**County of San Diego  
Planning & Development Services  
BUILDING DIVISION**

ACCESSIBILITY CORRECTION LIST Multifamily Housing	<b>9A</b>
<b>Common-Use Toilet Facilities</b>

(b) SINGLE-ACCOMMODATION TOILET FACILITY

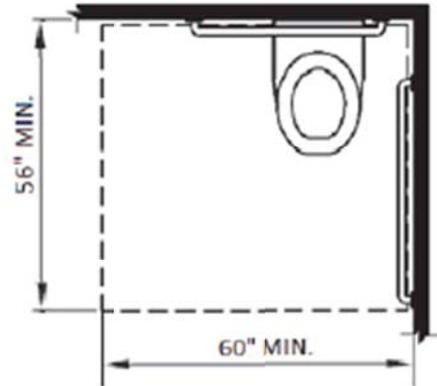
6. Dimension sufficient space within toilet facility for wheelchair measuring minimum 30-inches-wide by 48-inches-long to enter room and allow door to close. CBC 1127A.2.2.1

7. Dimension within toilet facility clear floor space and maneuvering space per the following:
  - Turning space per CBC Figure 11A-9A(b):
    - o Minimum 60-inch-diameter or equivalent T-shaped space

- o May include maximum 19-inch deep knee and toe clearance per items 32 and 33 beneath lavatory
    - o Maximum 12-inch door encroachment
    - Exception:** Additional door encroachment allowed into turning space if minimum 30-inch-wide by 48-inch-deep clear floor space provided in room beyond arc of door swing

- Clear floor space around toilet per CBC Figure 11A-9B(c):
    - o Minimum 60-inch width measured perpendicular from side wall
    - o Minimum 56-inch depth measured perpendicular from rear wall

- o No fixture encroachment other than toilet, grab bars, or dispensers
    - o No door encroachment
    - Exception:** Door encroachment allowed into clear floor space if minimum 30-inch-wide by 48-inch-deep clear floor space provided in room beyond arc of door swing

- Maneuvering space in front of toilet per CBC Figure 11A-9A(b):
    - o Minimum 60-inch width measured perpendicular from side wall
    - o Minimum 48-inch depth measured perpendicular from front of toilet

**(c) ACCESSIBLE WATER CLOSET COMPARTMENT  
WITHIN MULTIPLE-ACCOMMODATION TOILET FACILITY**

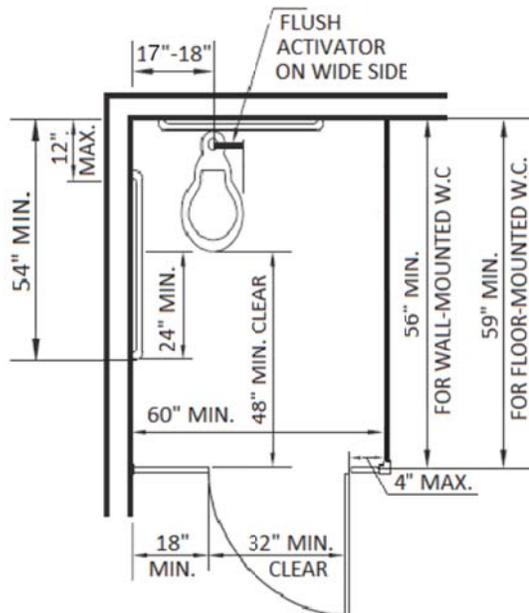
13. Dimension clear floor space at toilet per CBC Figure 11A-9A(c):

- Minimum 60-inches wide by 56-inches deep – measured from rear wall – for wall-mounted toilet
- Minimum 60-inches wide by 59-inches deep – measured from rear wall – for floor-mounted toilet
- No door encroachment

**(d) AMBULATORY ACCESSIBLE COMPARTMENT**

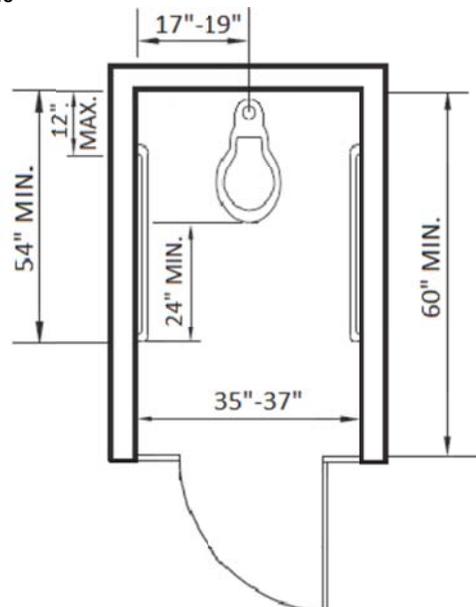
**15. In toilet facilities with six or more toilet compartments or six or more toilets and urinals, provide at least one toilet compartment – in addition to accessible toilet compartment required per item 9 – complying with the following ambulatory accessibility features per CBC Figure 11A-9A(d):**

- Minimum 35-inch and maximum 37-inch width
- Minimum 60-inch depth
- Outward swinging, self-closing door with compliant door hardware and pull and adequate strike edge clearance
- Grab bars on each side per item 20

(a) SIDE VIEW

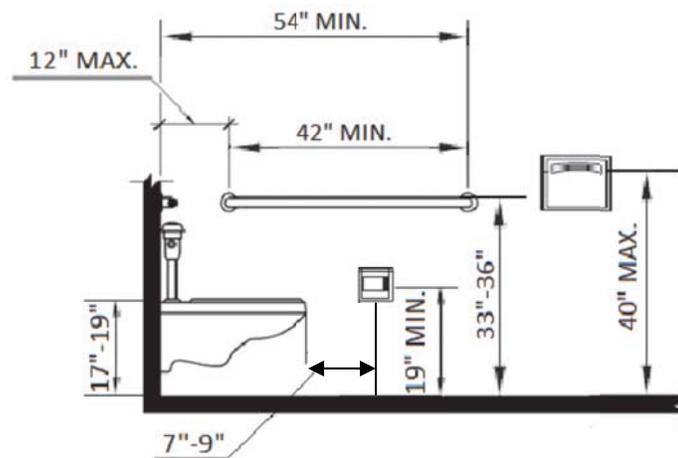
20. Provide grab bar on side wall closest to toilet and dimension to comply with the following per CBC Figure 11A-9B(a):
- Minimum 42-inches long
  - Positioned maximum 12 inches from rear wall
  - Extending minimum 54 inches from rear wall
  - Extending minimum 24 inches in front of toilet
  - Mounted horizontally at minimum 33 inches and maximum 36 inches from finished floor to top of gripping surface

(b) FRONT VIEW

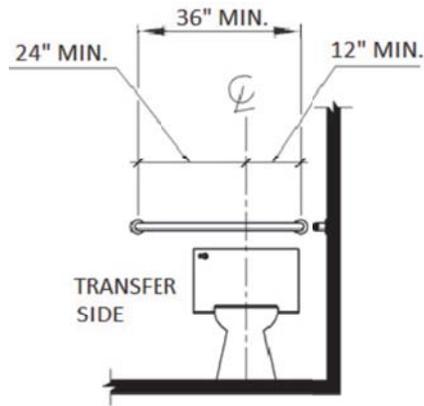
21. Provide grab bar on rear wall behind toilet and dimension to comply with the following per CBC 11A-9B(b):
- Minimum 36-inches long
- Exception:** Minimum 24-inch length, centered on toilet, acceptable where wall space does not allow 36-inch length due to location of a recessed fixture adjacent to toilet
- Extending from centerline of toilet minimum 12 inches on one side
  - Extending from centerline of toilet minimum 24 inches on other side
  - Mounted horizontally at minimum 33 inches and maximum 36 inches from finished floor to top of gripping surface

(b) NON-CIRCULAR CROSS SECTIONS

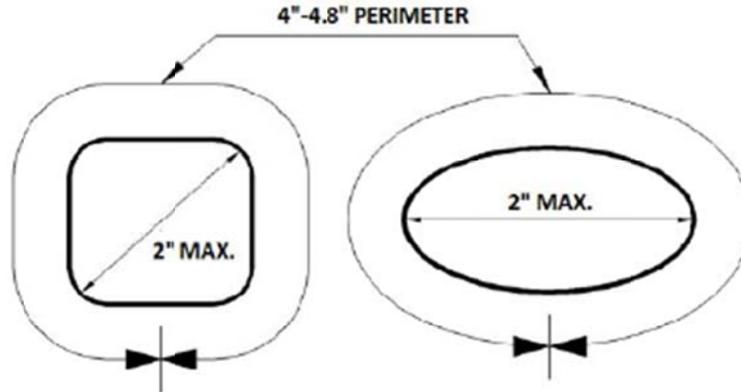
22. Detail the grab bar gripping surfaces per the following:

- ❑ If cross section is circular, minimum 1-1/4-inch and maximum 2-inch outside diameter
- ❑ If cross section is non-circular, minimum 4-inch and maximum 4.8-inch perimeter and maximum 2-1/4-inch cross-section dimension per CBC Figure 11A-9C(b)

(a) SECTION THROUGH TYPICAL CIRCULAR GRAB BAR

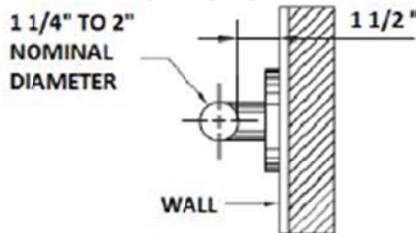
23. Detail grab bar clearance from adjacent elements per the following:

- ❑ For grab bars mounted adjacent to a wall, 1-1/2-inch (absolute) space between the wall and grab bar per CBC Figure 11A-9C(a)
- ❑ Minimum 1-1/2-inch space between grab bar and projecting objects below and at ends
- ❑ Minimum 12-inch space between grab bar and projecting objects above

(a) KNEE SPACE - GENERAL REQUIREMENT  
FIGURE 11A-9D  
KNEE AND TOE SPACE

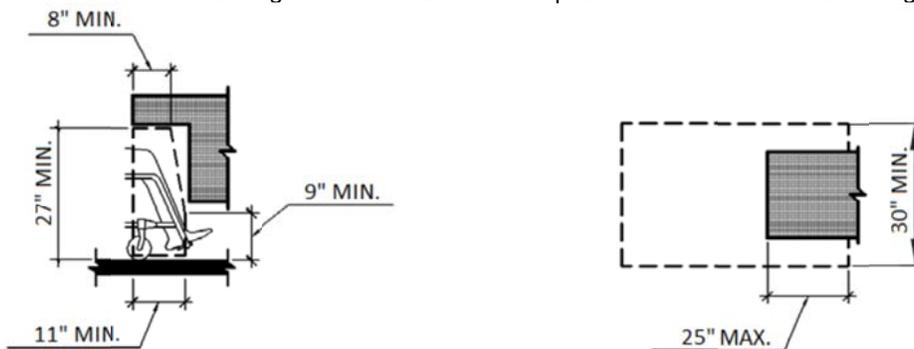
32. Detail knee clearance beneath accessible lavatories complying with the following per CBC Figure 11A-9D(a):

- Minimum 30 inches wide
- Minimum 8 inches deep
- Minimum 29 inches at front face reducing to minimum 27 inches at point 8 inches back from front edge

(b) TOE SPACE - GENERAL REQUIREMENT  
FIGURE 11A-9D  
KNEE AND TOE SPACE

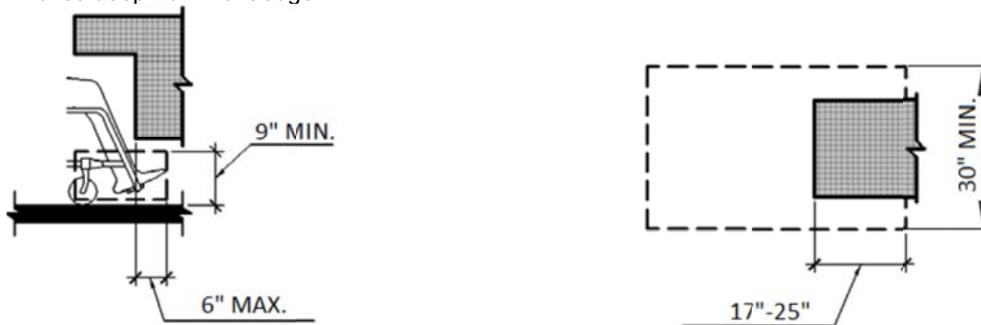
33. Detail toe clearance beneath accessible lavatories complying with the following per CBC Figure 11A-9D(b):

- Minimum 30 inches wide
- Minimum 9 inches high
- Minimum 17 inches deep from front edge
